Access Compliance Report

Public Rights-of-Way

Intersection ID: 11423	Main Street: S SUMMIT_AV	Cross Street: W 4TH_ST_EXT	Location: NE
ADA ID: 3DBE8E4EA83D	Ramp Type: Directional1	Initial Pass/Fail: Pass	Overall Compliance: No
		Severity Score: 0

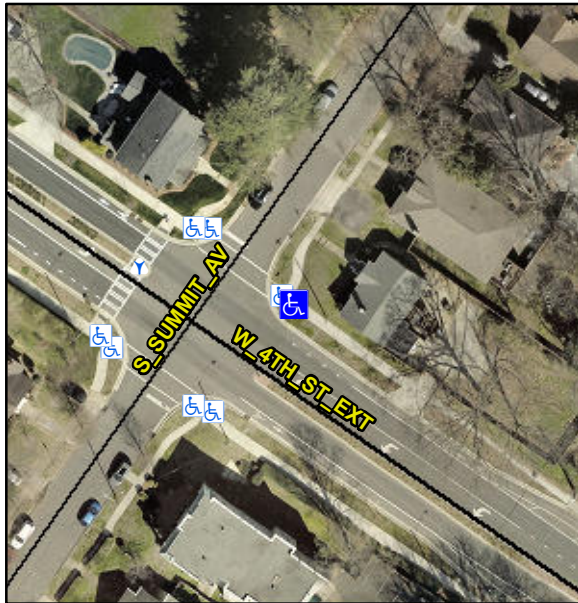
R304.5.2

Compliance	Description	Data	Compliance	Description	Data
N/A	Ramp Length (in)	60.0	No	Grade Break?	No
Yes	Ramp Width (in)	70.0	N/A	Grade Break Slope (%)	N/A
Yes	Ramp Slope (%)	7.4	N/A	Grade Break XSlope (%)	N/A
Yes	Ramp XSlope (%)	1.3			
Yes	Flare Type LT	N/A	Yes	Flare Type RT	N/A
N/A	Flare Slope LT (%)	N/A	N/A	Flare Slope RT (%)	N/A
N/A	Flare Traversable LT?	No	N/A	Flare Traversable RT?	No
Yes	Landing Length (in)	71.0	Yes	DWS Provided?	Yes
Yes	Landing Width (in)	70.0	Yes	DWS Contrast?	Yes
Yes	Landing Slope (%)	1.0	Yes	DWS Length (in)	24.0
Yes	Landing X Slope (%)	0.4	Yes	DWS Full Width?	Yes
N/A	Landing Curb? (Y/N)	N/A	Yes	DWS Offset LT (in)	0.0
N/A	Shared Landing?	Yes	Yes	DWS Offset RT (in)	0.0
Yes	Gutter Ponding?	No	Yes	Gutter Slope (%)	0.3
Yes	Gutter Lip Ht (in)	0.0	Yes	Gutter X Slope (%)	2.5
N/A	Painted X Walk1?	No		Road Slope (%)	0.2
	X Walk 1 Direction	To SW		Road X Slope (%)	3.1
	X Walk 1 Width (in)	N/A		Clear Space?	Yes

Remove & Replace Entire Ramp.
